Final Environmental Impact Report

Volume 3 of 5

For the
San Francisco Public Utilities Commission's
**Regional Groundwater Storage and Recovery
Project**

San Francisco Planning Department
Case No. 2008.1396E
State Clearinghouse No. 2005092026

Figure 3-2 REVISED

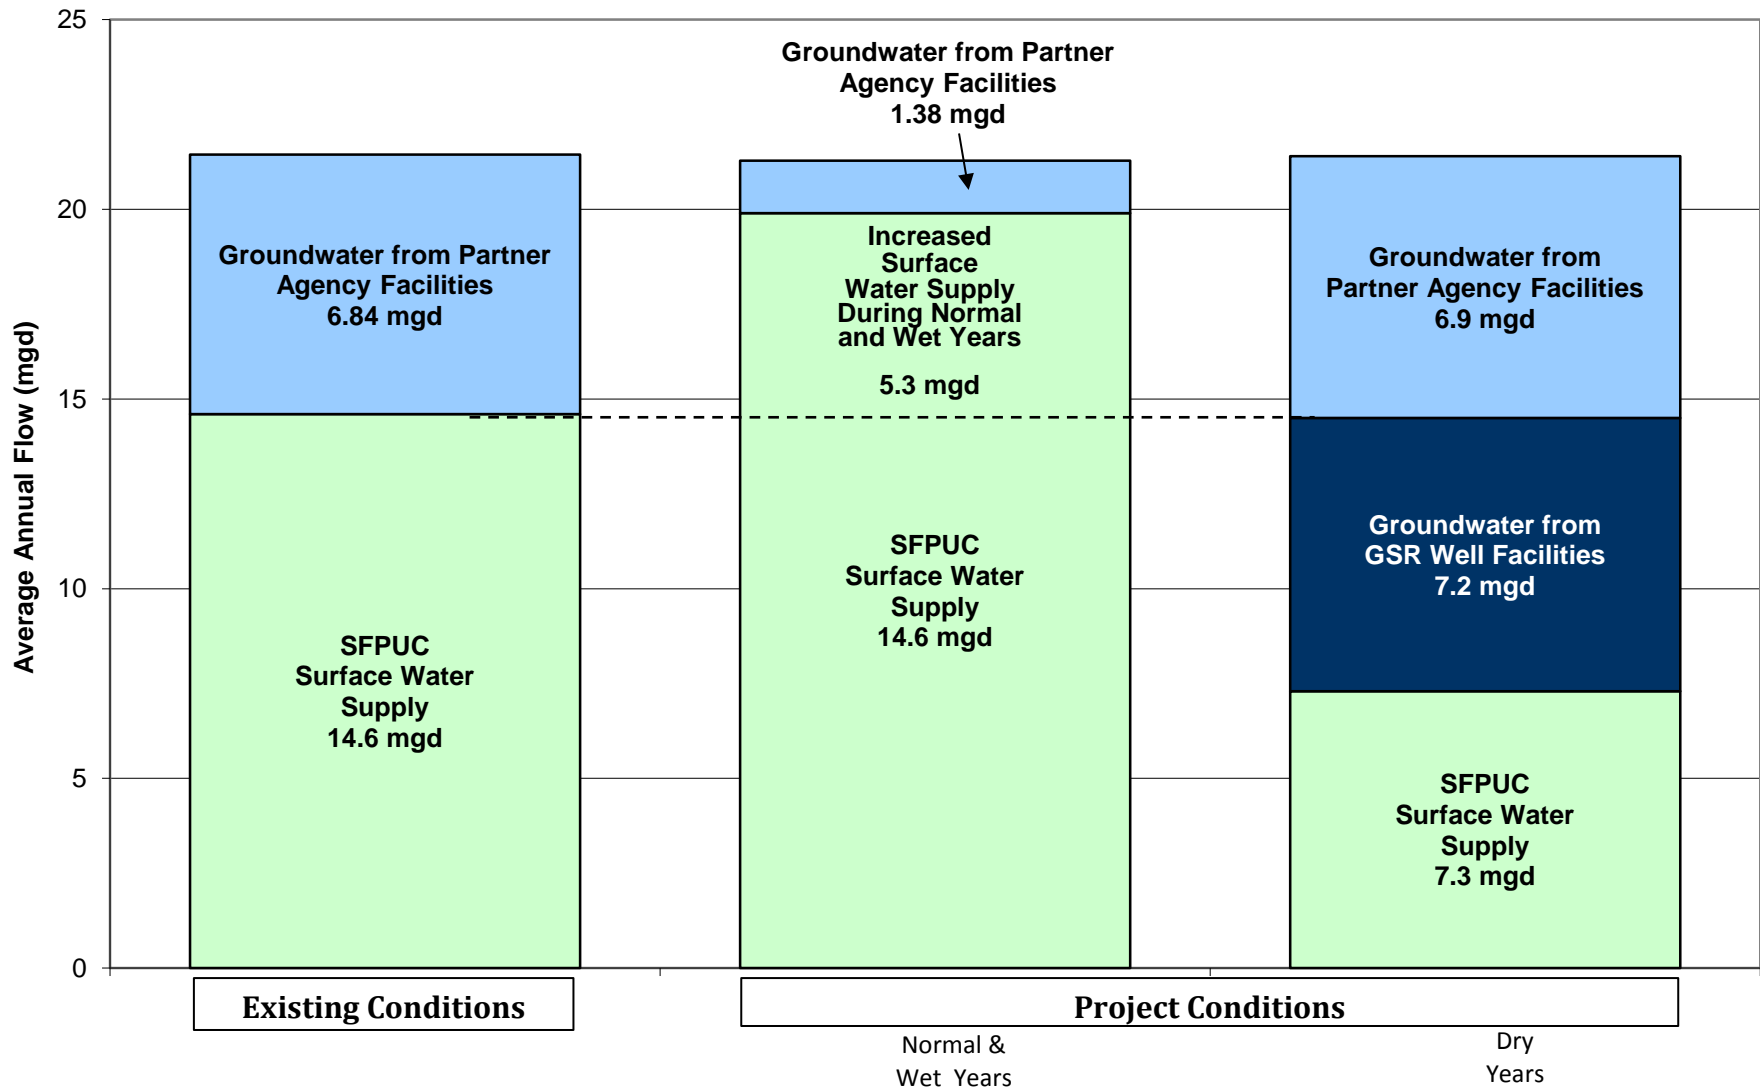
“8. Section 3.4.1 – Groundwater Storage and Recovery, Figure 3-2 (page 3-9). The volume of surface water deliveries should be added to the Project Conditions portion of Figure 3-2. Also, for Figure 3-2, please clarify, what year the demand is representative of (i.e. is it current conditions or 2035 conditions).”
(BAWSCA, letter, May 24, 2013 [G-BAWSCA-Sandkulla])

The comment requests changes to figures in Chapter 3, Project Description. Regarding Figure 3-2 (Source of Proposed Water Supply for Partner Agencies) in Chapter 3, Project Description of the Draft EIR, the figure shows sources of supply, not demand. The figure shows surface water supplies for both existing and Project conditions (please refer to the labels on the lower axis of the figure). To further clarify the sources of supply during normal and wet years under the Project, the green portion of the center bar is revised on the graph to show 14.6 mgd of the SFPUC surface water supply, which corresponds to the amount currently available under existing conditions, and 5.3 mgd of “increased surface water supply during normal and wet years” in the area above the dotted line on the bar chart. This represents the additional surface water that would be supplied to Partner Agencies to allow a reduction in pumping, thereby providing in-lieu recharge. Please refer to Revised Figure 3-2, which follows this page.

Description of Revision: Figures 3-2 (Source of Proposed Water Supply for Partner Agencies) and 3-37 (Site 16, Millbrae Corporation Yard) have been revised and are included in Section 9.3.3, Project Description, of this Responses to Comments. Figure 3-2 has been revised in response to Comment PD-3, which requested that the volume of surface water deliveries be added to the Project Conditions portion of the figure, so as to clarify the sources of supply during normal and wet years. Figure 3-37 has been revised in response to Comment PD-3 to correct the identification of labeling of an existing building near Site 16; the label has been revised from convalescent hospital to multi-family residential.

Figure 3-24 REVISED

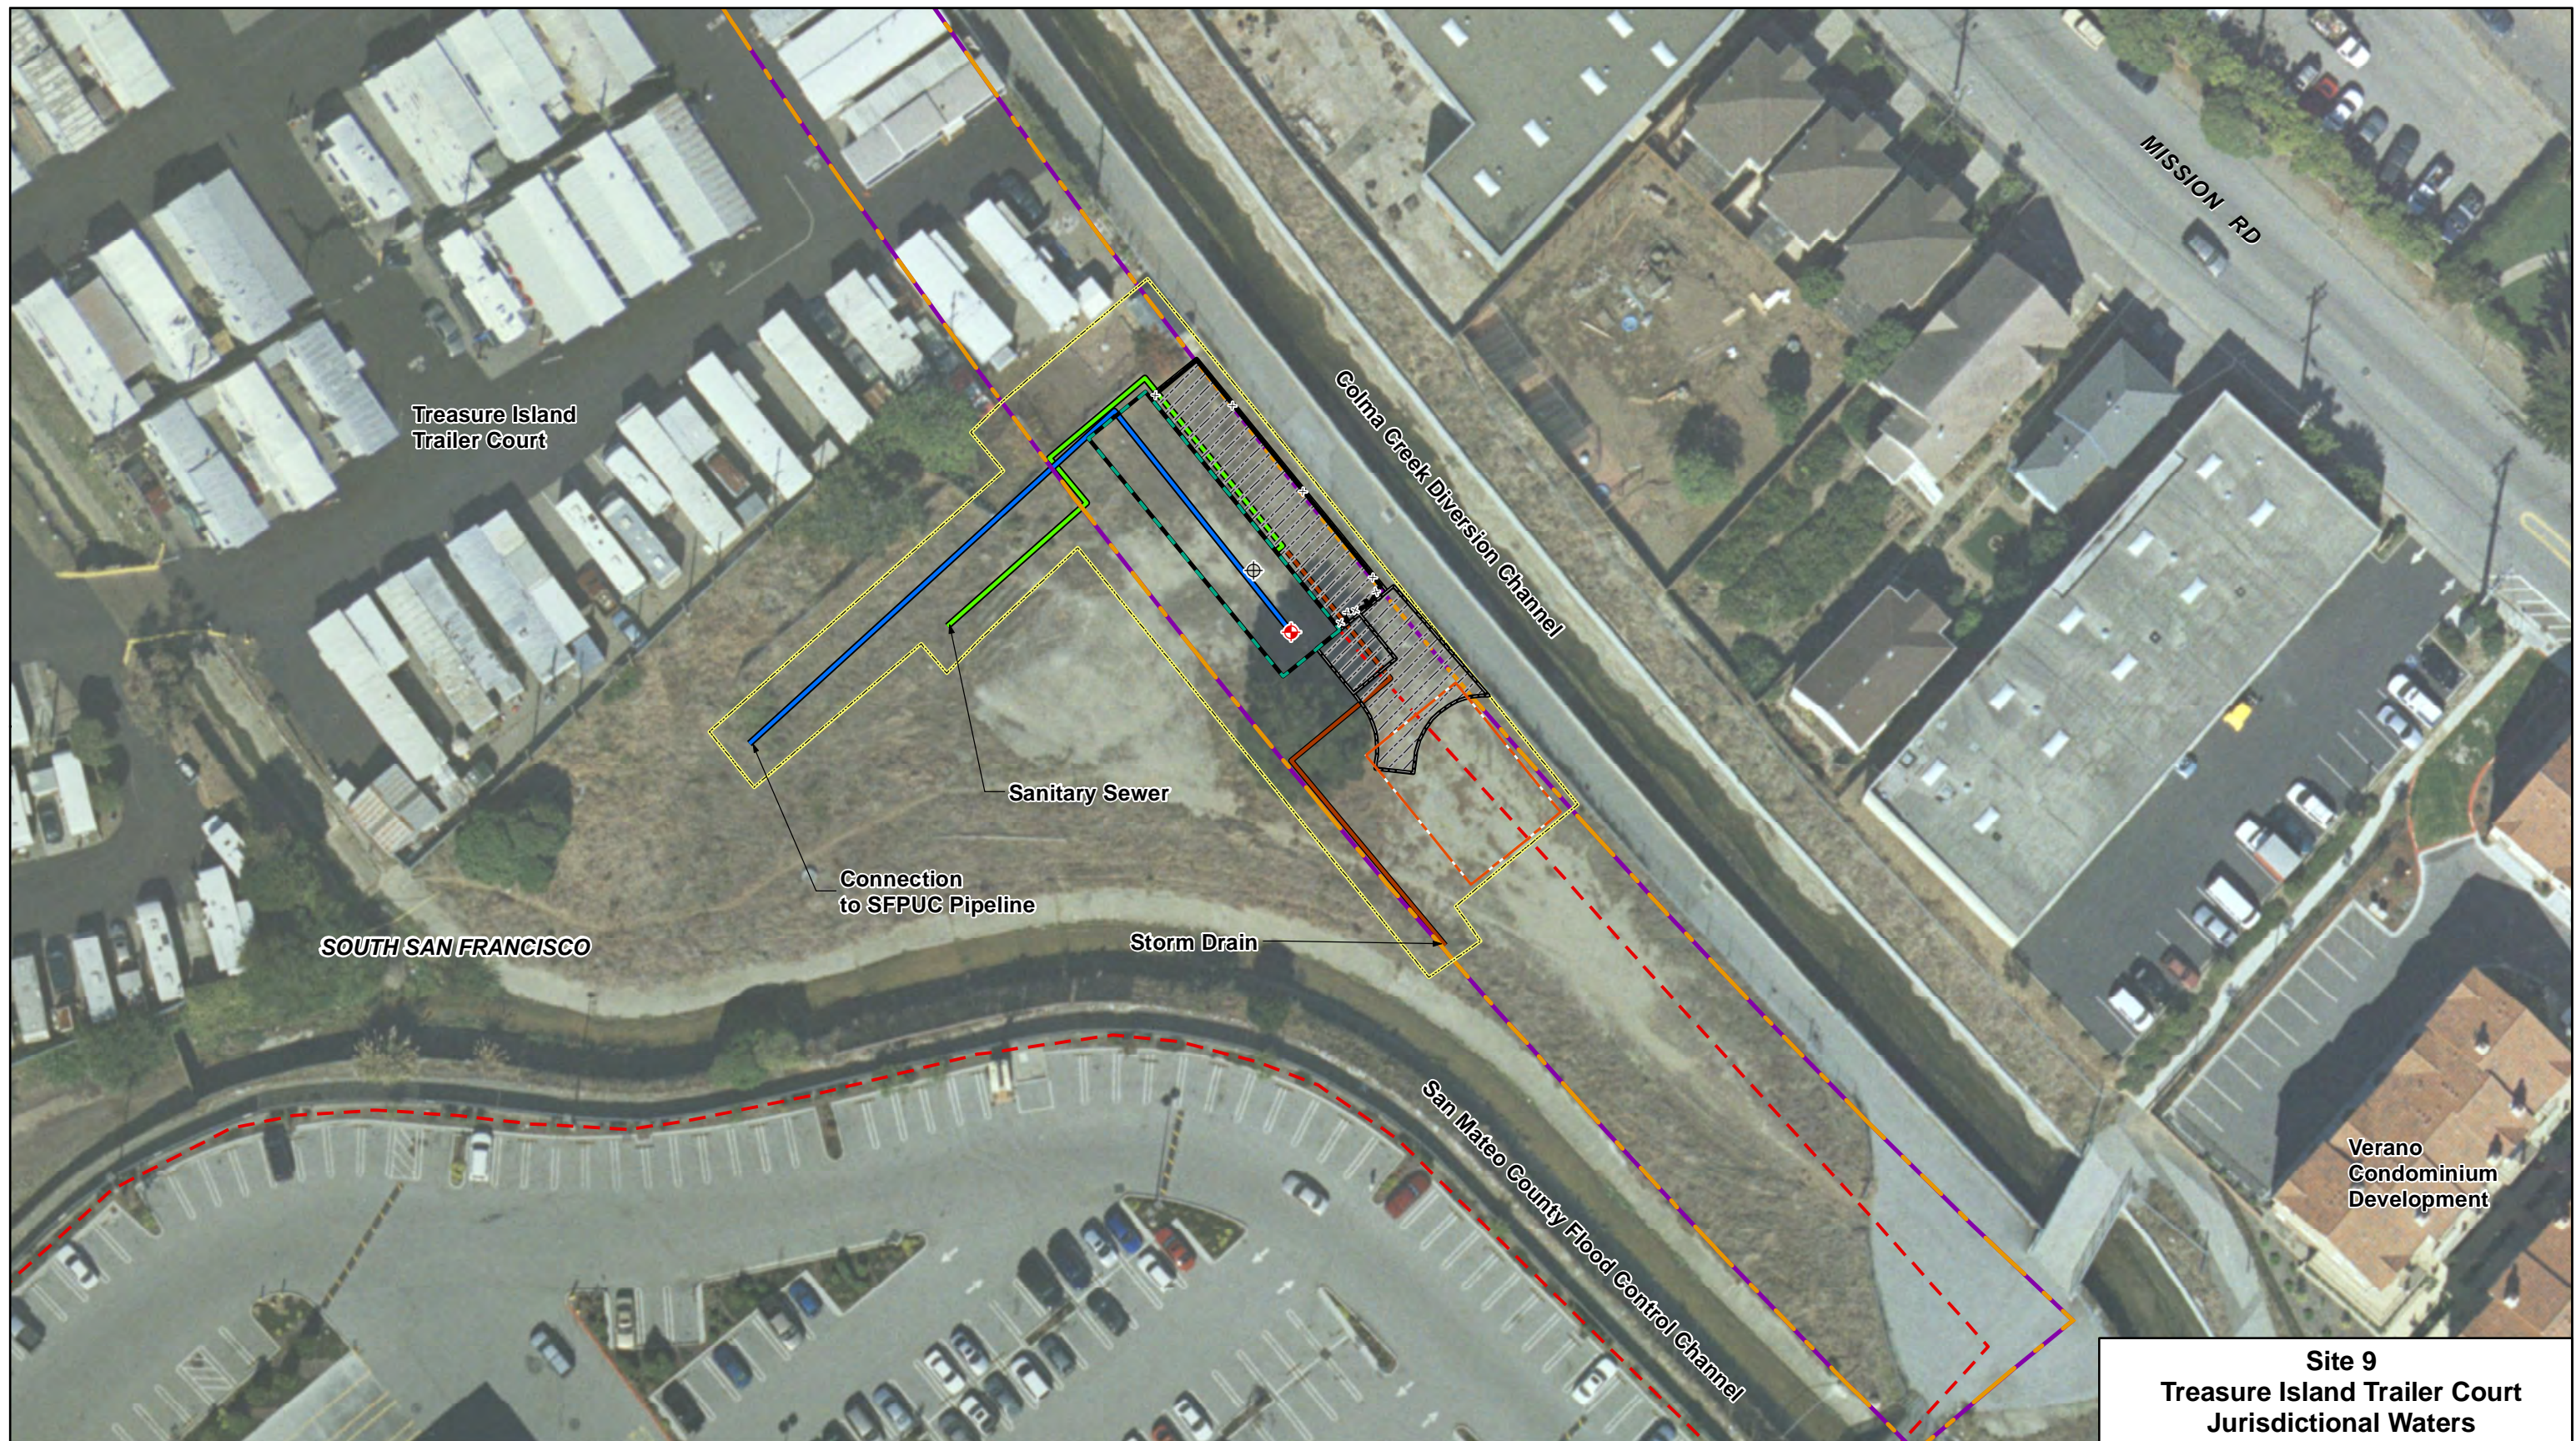
"*Site 9 Overhead Electrical Connection.* Figure 3-4 shows that Site 9 requires an electrical connection through a commercial business in the Town of Colma. This electrical connection is proposed to be above ground, which is unacceptable. The line would impact the existing commercial business and visually impacts views from the Verano neighborhood. The Town of Colma requires undergrounding of utilities for all new construction, from the pole to the project site pursuant to Municipal Code Section 5.09. In addition, General Plan policy 5.02.361 requires that all new construction projects to place utilities

Draft EIR Figures 3-23 (Site 9, Access Road, Treasure Island Trailer Court), 3-24 (Site 9, Treasure Island Trailer Court) and 5.14-7 (Site 9, Treasure Island Trailer Court, Jurisdictional Waters) have also been revised to reflect this change.

In response to Comment PD-5, Figure 3-23 (Site 9 Access Road Treasure Island Trailer Court) (page 3-77) and Figure 3-24 (Treasure Island Trailer Court) (page 3-78) are revised to reflect the buried electrical line to Site 9. The revised figures are presented in Section 9.3.3, Project Description, of this Responses to Comments document.

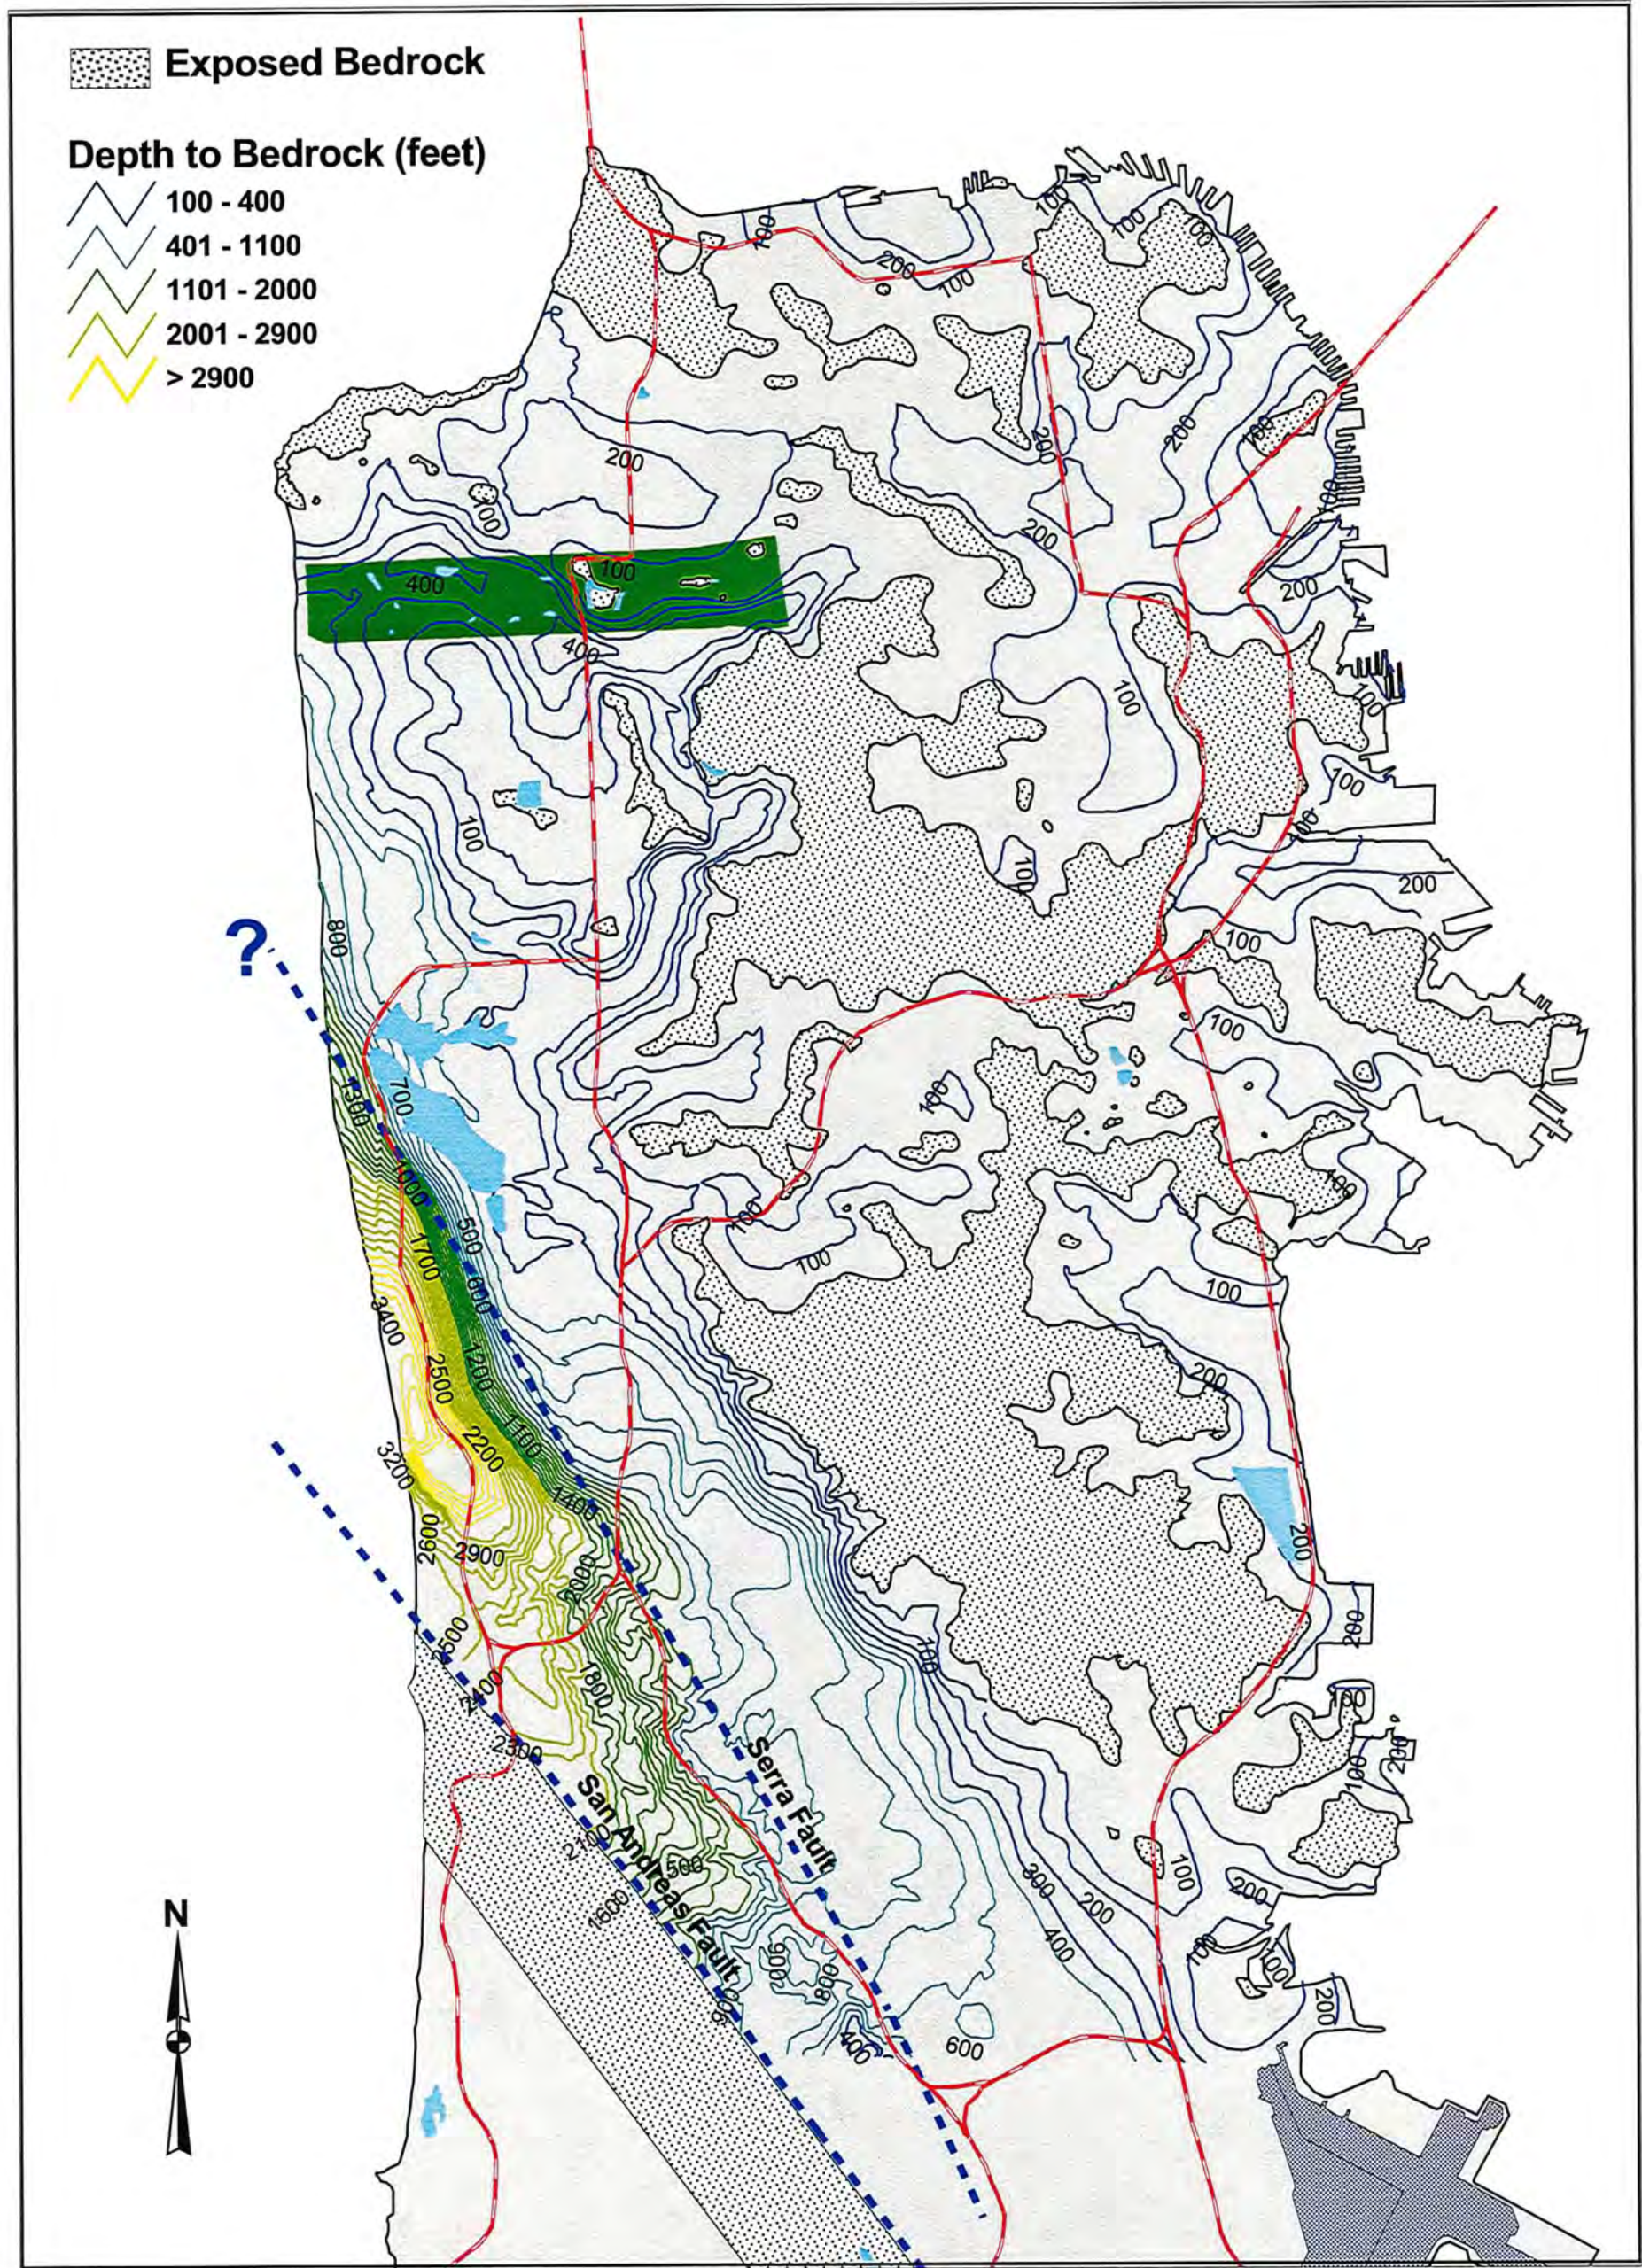
The DEIR includes one cross section that runs the length of the Westside Basin. The Westside basin covers an extensive area and includes several faults that are significant hydrologic barriers. Cross sections perpendicular to the axial cross section will demonstrate the subsurface barrier boundaries along the northeast and southwest sides of the South Westside Basin.” (*Cypress Lawn Memorial Park, letter, June 11, 2013 [O-CLMP-Quick]*)

“Item 32 – Why were water levels not included on the cross section?”

The DEIR discusses the water level variability across the Westside Basin and between the various aquifers. It would be very useful to see how measured water levels do in fact vary across the basin and between the aquifers.” (*Cypress Lawn Memorial Park, letter, June 11, 2013 [O-CLMP-Quick]*)

The cross-section, Figure 5.16-2 (North-South Geologic Cross Section, Westside Groundwater Basin), included in the Draft EIR, was selected as being most representative of the characteristics of the groundwater basin that are important to understanding the impact analysis. Additional north-south cross-sections of the basin are included in Appendix H, *Task 10.1 Technical Memorandum, Groundwater Modeling Analysis for the Regional Groundwater Storage and Recovery Project and San Francisco Groundwater Supply Project*, Figure 10.1-3 and the TM's Attachment 10.1-H Figure 7. A reference cited in Draft EIR Section 5.16, Hydrology and Water Quality, *TM 1 Hydrologic Setting of the Westside Basin* (LSCE 2010), provides additional existing setting information relative to seawater intrusion. A figure from the 2010 LSCE report shows the relationship of bedrock to the Serra Fault and other geologic features, and several figures from the report include east-west cross-sections which show the relationship of groundwater basin features in the Westside Groundwater Basin both east and west of the Serra Fault. These figures address the information requested by the comment and are included with this response for reference as Figures RTC-1 (Depth to Bedrock) and RTC-2 through RTC-19 (Cross Section Location Map and cross-sections), respectively.
